August 3, 1984

HOPE CREEK GENERATING STATION  
DOCKET NO. 50-354  
DRAFT SAFETY EVALUATION REPORT  
OPEN ITEM STATUS

In addition, enclosed for your review and approval (see Attachment 4) are the resolutions to the Draft SER open items, FSAR question responses and structural geotechnical audit item responses, listed in Attachment 3.

FIGURE 4

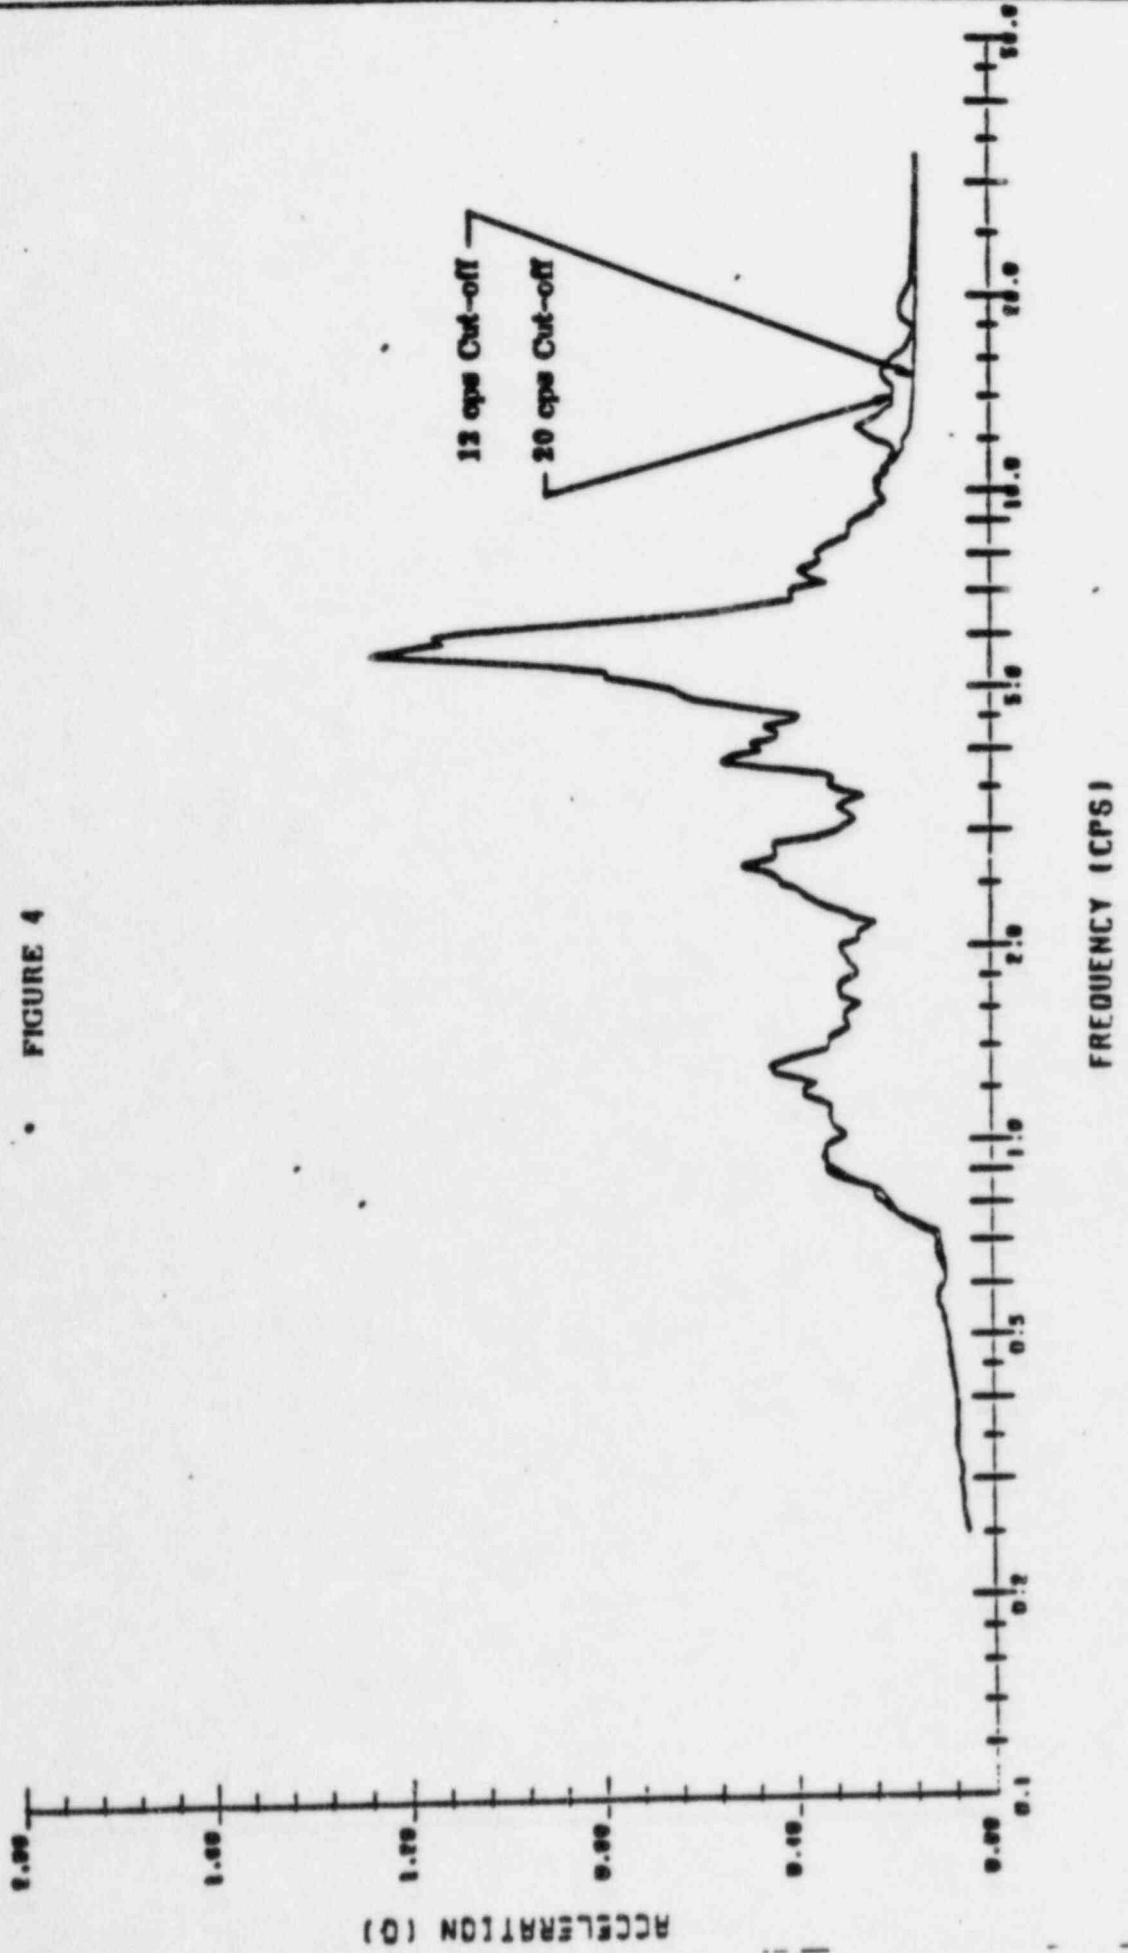
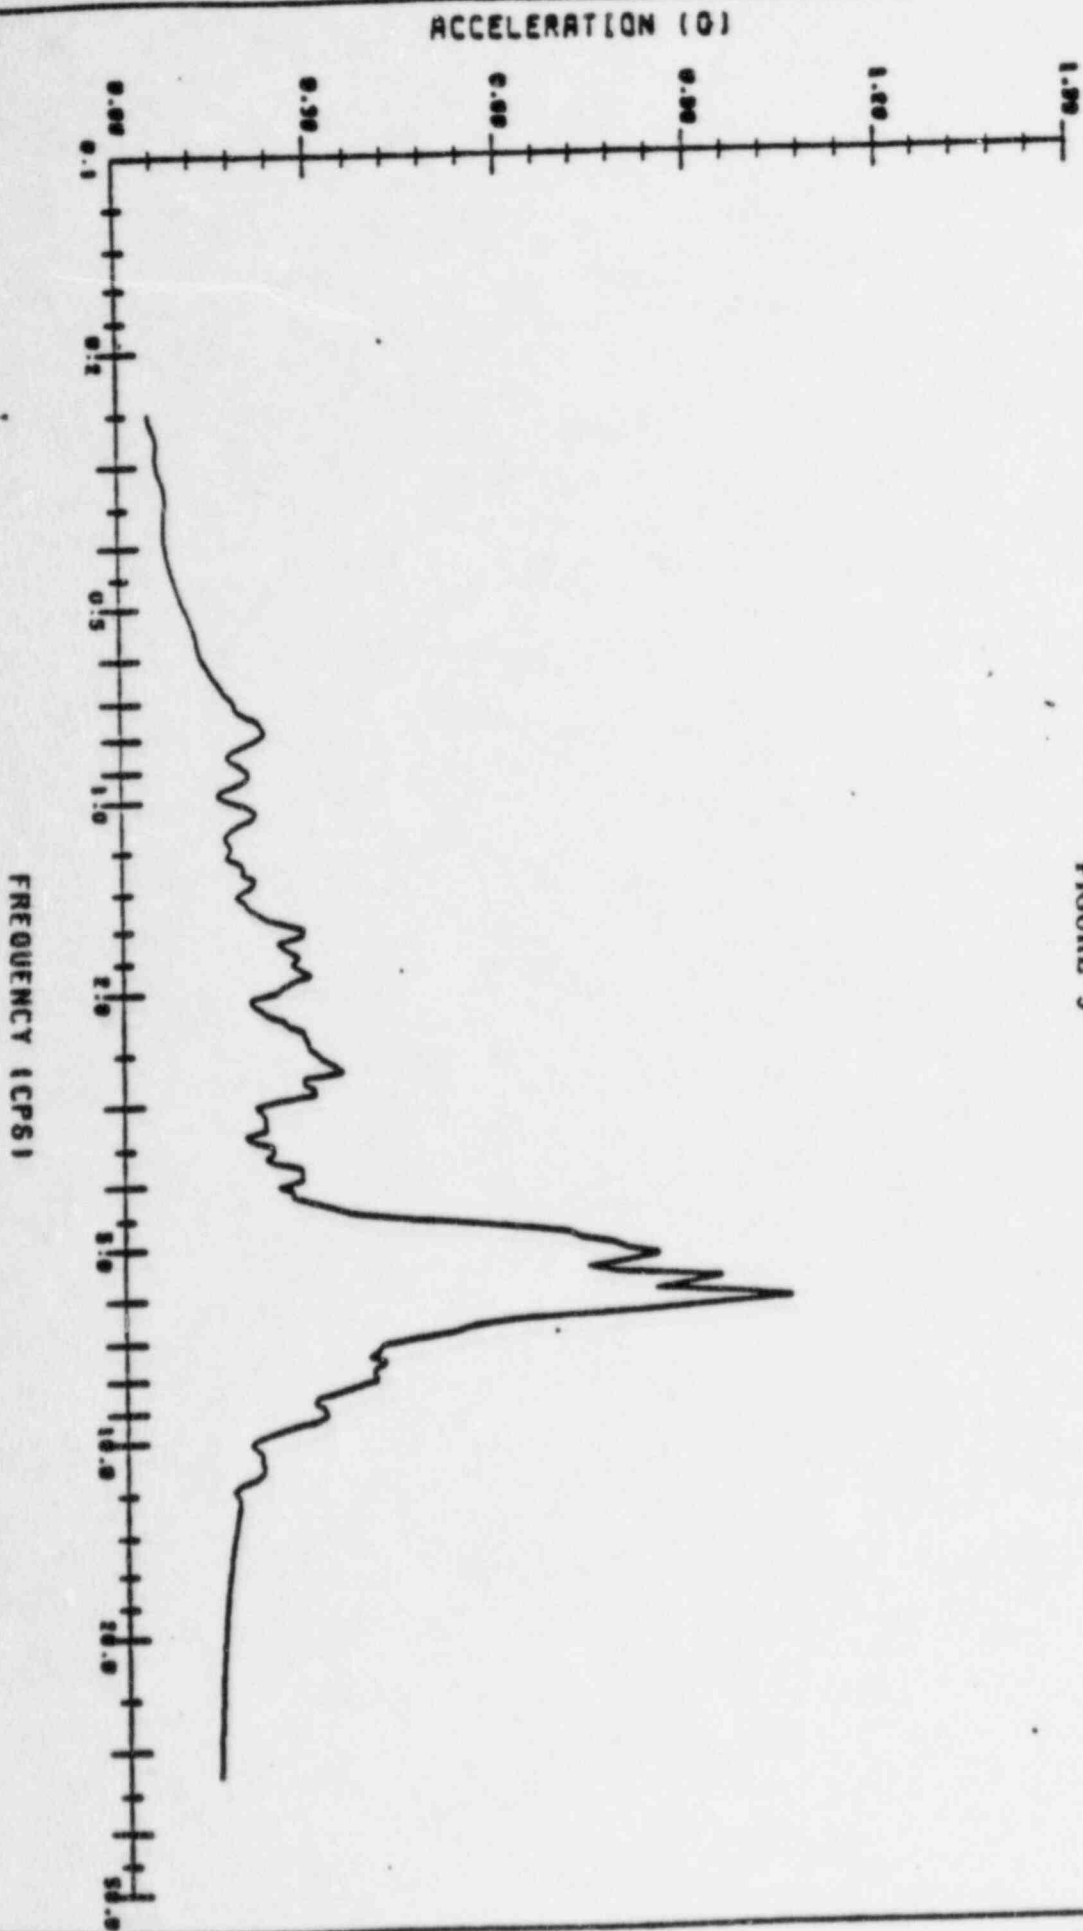
A soil column, representing the Hope Creek free-field soil properties, was first constructed. The mesh refinement was selected such that a wave frequency of 20 Hz. could be transmitted without loss of numerical accuracy. A schematic representation of the soil column model is presented in Figure 1.

As demonstrated by Figure 4, the base mat response for the two cut-off frequencies are essentially identified for the frequency range below 12 Hz. For the frequency range of 12 to 20 Hz., however, the response at the base mat does diverge somewhat between the two cut-off frequencies. The 20 Hz. cut-off response exhibits a number of minor peaks, as a result of high frequency components of the bedrock motion. The effect of these minor peaks on structural response is insignificant as verified by the seismic structural analysis described in the following section. The 12 Hz. cut-off analysis, on the otherhand, exhibits a non-amplified response beyond 12 Hz., resulting in a constant spectral acceleration.

In order to verify the adequacy of the simplified model, a comparison with a detailed interaction model was made. A comparison of Figures 4 and 5 reveals that the motion at the base mat for the detailed and simplified models exhibit very similar trends, both with regard to the spectral peak and overall shape of the curves.
